Agenda Item:           **Consideration – An Ordinance Approving Final Development Plans and a Final Plat of Subdivision for a ±60 Acre Warehouse/Distribution Development Known as Huntley Commercial Center (former Huntley Outlet Center)**

Petitioner/Owner:    **Huntley Investment Partners, LLC**

BUILDING ELEVATIONS & FINAL SIGNAGE PLAN  
CHI17-0051-00  
05.27.2021

## HUNTLEY, ILLINOIS LANDSCAPE DEVELOPMENT PLANS

**SHEET NUMBER 24**

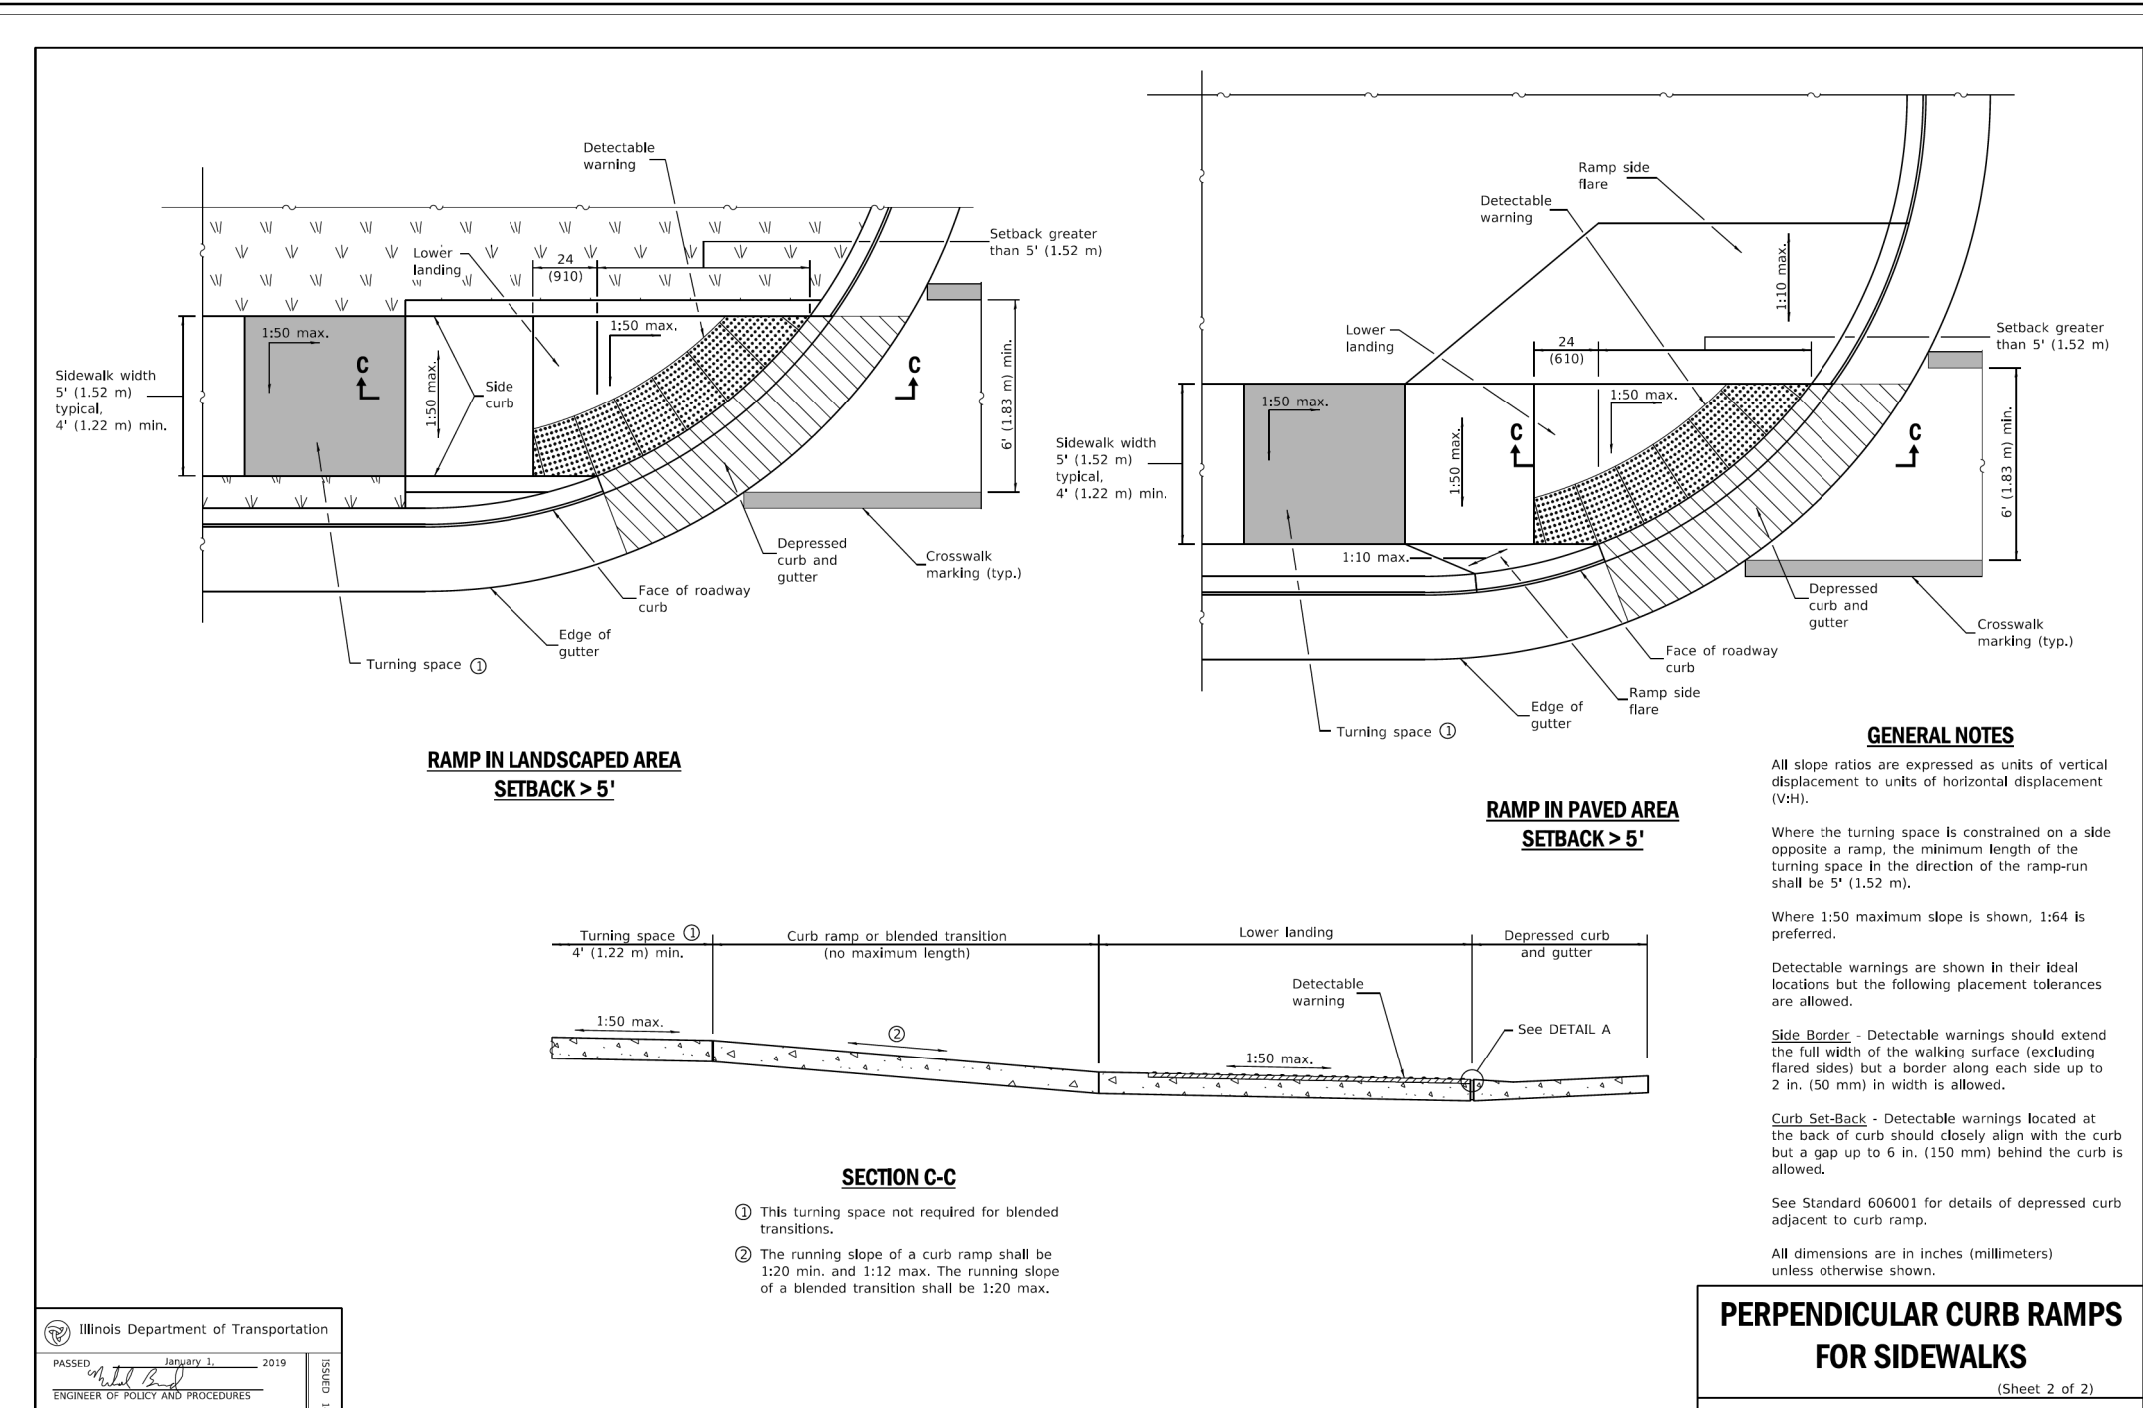
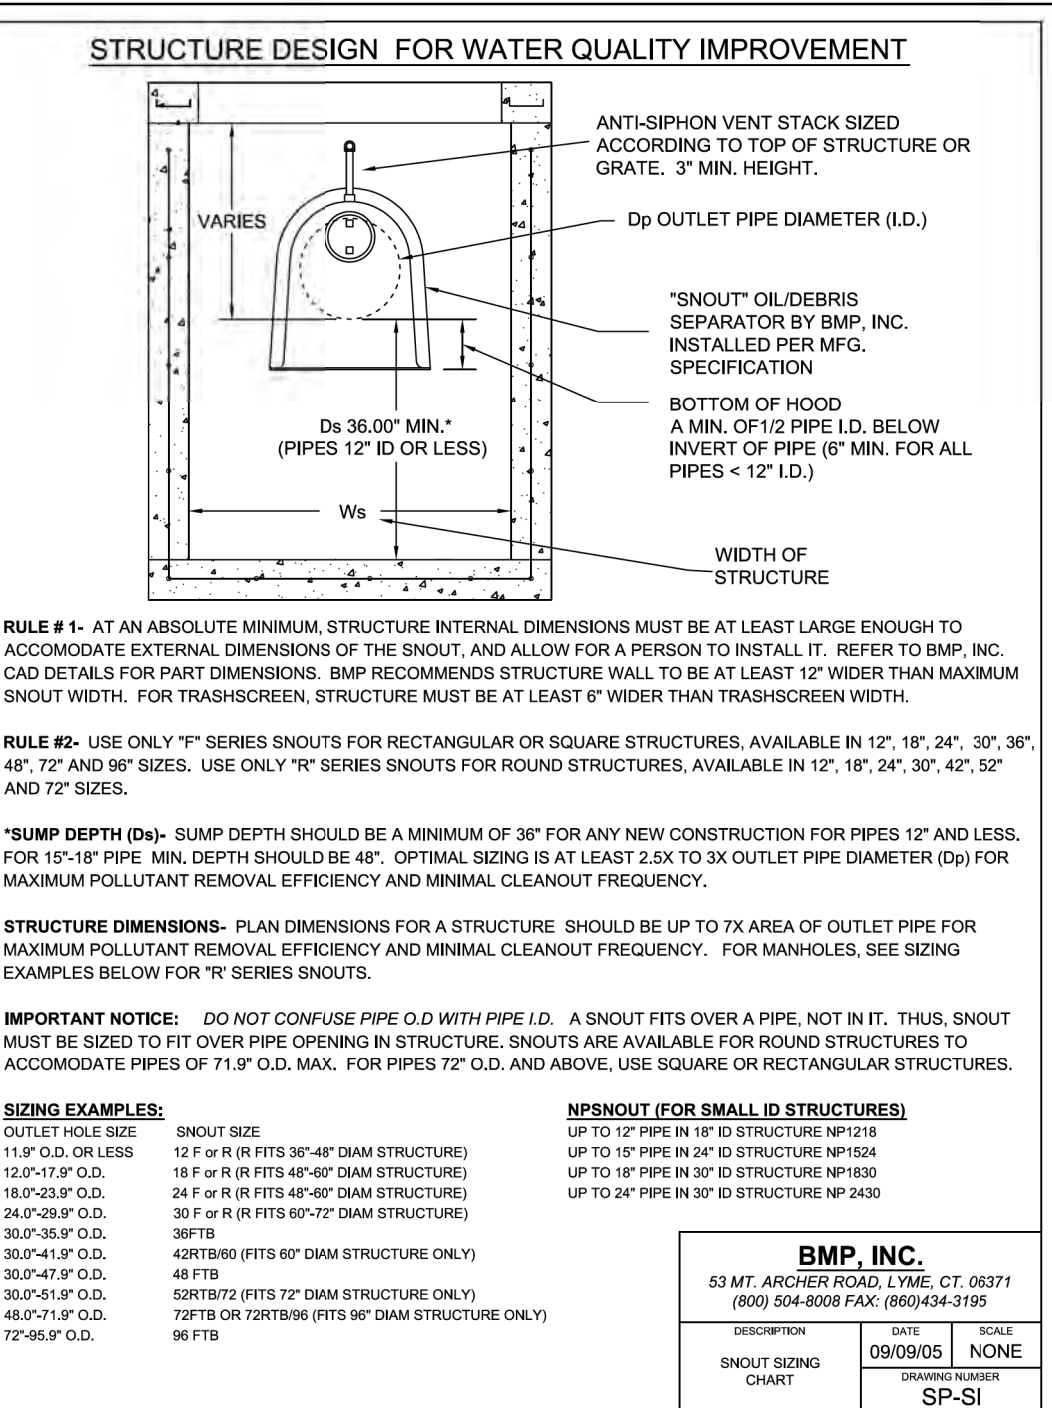
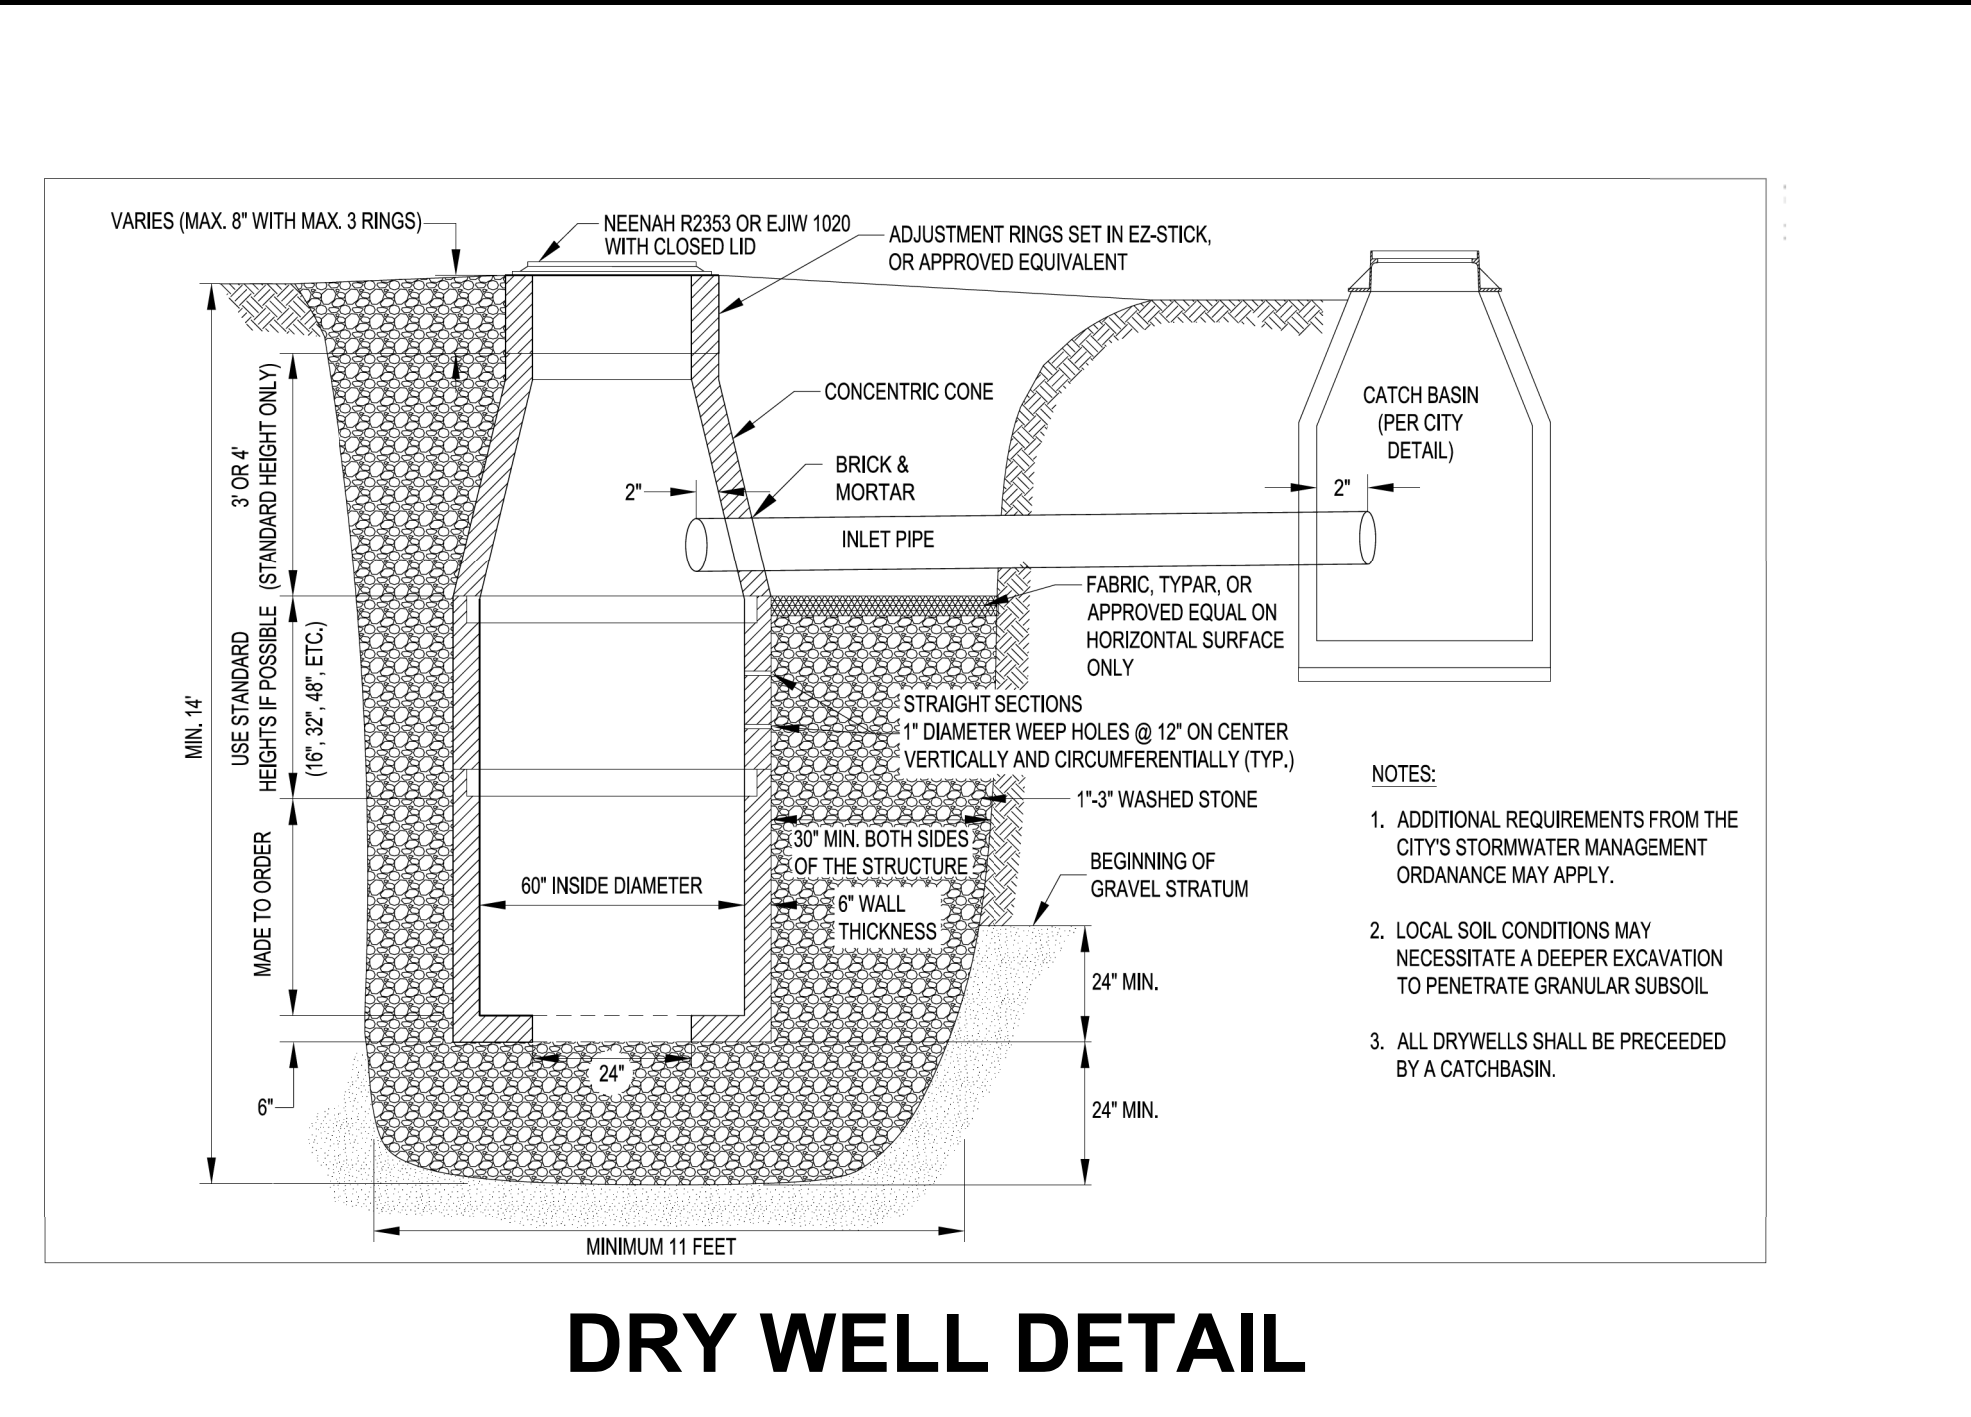
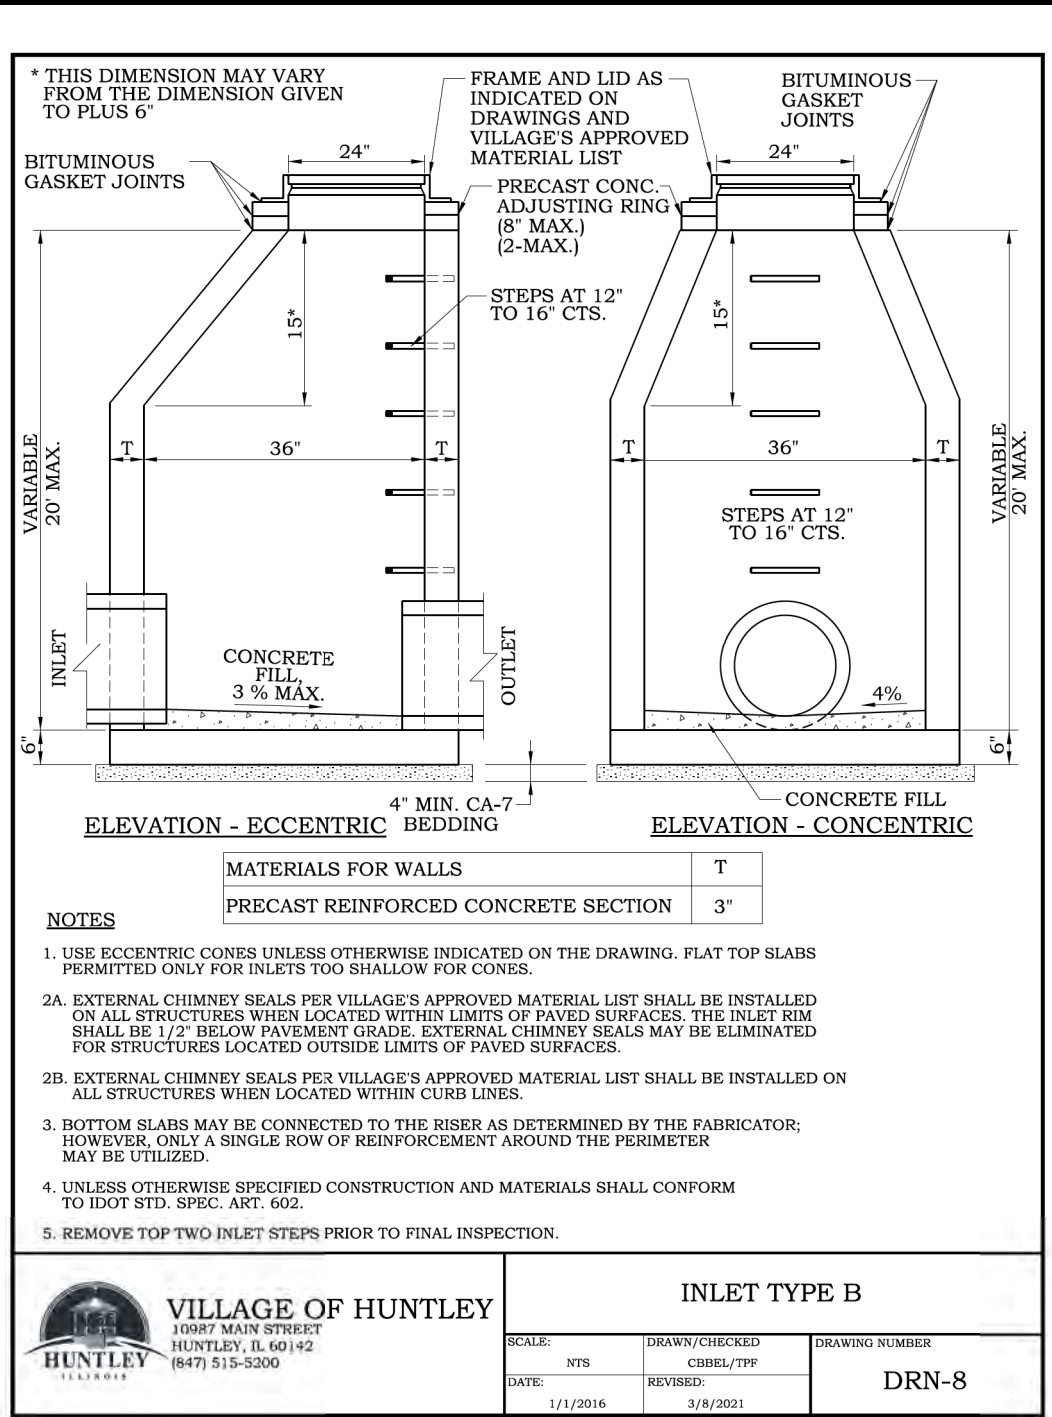
67. The most recent Village of Huntley standard details shall be incorporated into the plan set. (Typical to sheets 24 & 25)
68. IDOT standard ADA curb ramp details shall be incorporated into the plans related to the various types of curb ramps required to complete the proposed improvements.
